Broken Longitudinal Torque Rod Mounting Stud in Axle Spring Seat

M-652-002

(November 2008)

Interference Between Brake Cam Tube Wing Bracket and Longitudinal Torque Rod

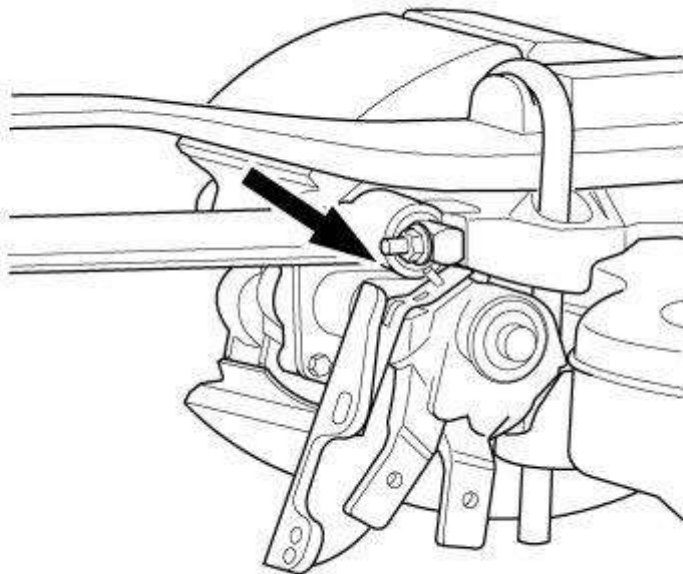
On certain CXU, CXP, CXN, CHU, CHN, GU, CTP and TD model chassis equipped with the MACK AL suspension and MACK rear axles, an interference condition may exist between the brake cam tube wing bracket and the longitudinal torque rod on the right-hand side of the chassis at both the front-rear and rear-rear axles.

Note: This interference condition occurs on the right-hand side of the chassis only. This condition is not seen on the left-hand side.

Should this interference condition be encountered at either the front-rear or rear-rear axle positions, replace both existing brake spiders (front-rear and rear-rear) with brake spider part number 8235- A3211Z6734. This brake spider orients the brake chamber 3 degrees lower from its original position. When replacing the brake spider, new mounting hardware must be used. Refer to the following illustration and chart for the required part numbers:

Spring Seat and Spring Clip (U-Bolt) Replacement

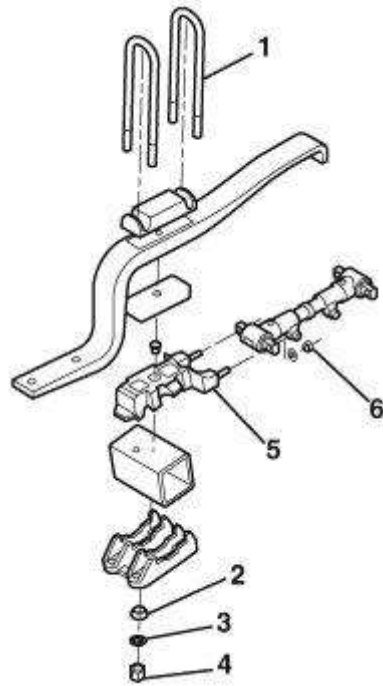
Contact between the brake cam tube wing bracket and the torque rod may eventually result in broken torque rod mounting studs. Should broken torque rod mounting studs be encountered, replacement of the spring seat(s) will be necessary. Disassembling the rear suspension for replacement of the spring seats requires replacement of the spring clips (U-bolts), washers and nuts. Part numbers are as follows:

After assembly, perform the following:

- Retorque the spring clips (U-bolts) and torque rod fasteners on the left-hand side of the chassis.
- Measure and adjust the suspension ride height.
- Check and adjust the rear axle alignment

After any repair procedure that involved removal and replacement of the spring clips (U-bolts), the spring clips must be retorqued after a minimum of one day or a maximum of one week or 5 000 km/3,000 miles of service.
